Ref: **CPP17939 Compass Centre Bankstown**

Impact of design changes on Natural Ventilation

Typical Unit B-09 / Unit B-601 [mirrored]:

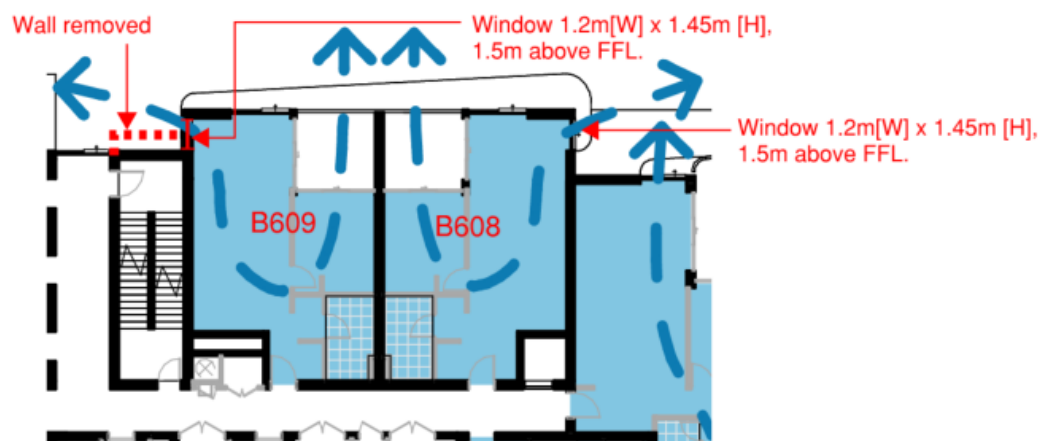
The wall adjacent to the side window has been removed to allow for a larger window (1.2 m [W] x 1.45 m [H], positioned 1.5 m above FFL), enhancing cross ventilation throughout the apartment.

Figure 2: Proposed design changes - Unit B609 to B2309 & B608 to B2308 (top) and Unit B601 to B2301 (bottom)

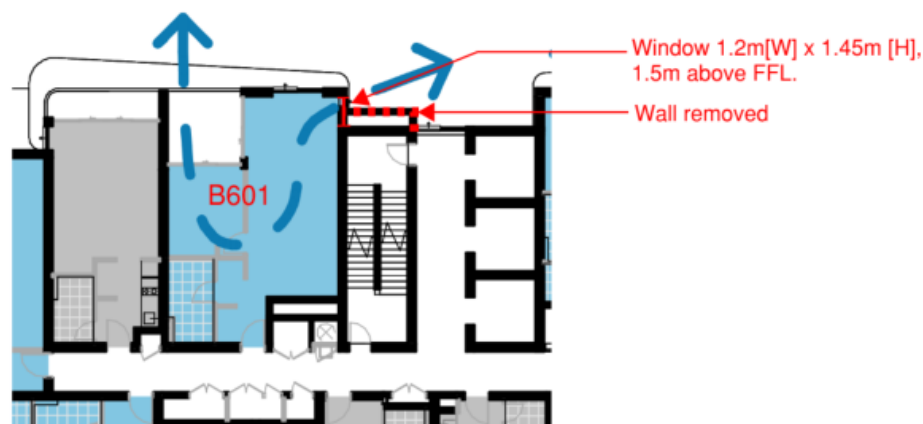
A minor adjustment has been made to improve cross ventilation within the apartments, as follows:

No updates have been made, as the current proposed window location and size already achieve effective cross ventilation. Refer to the CPP wind consultant's advice for confirmation.

The total natural ventilation compliance remained at 66%. (AGD requirement: 60%)
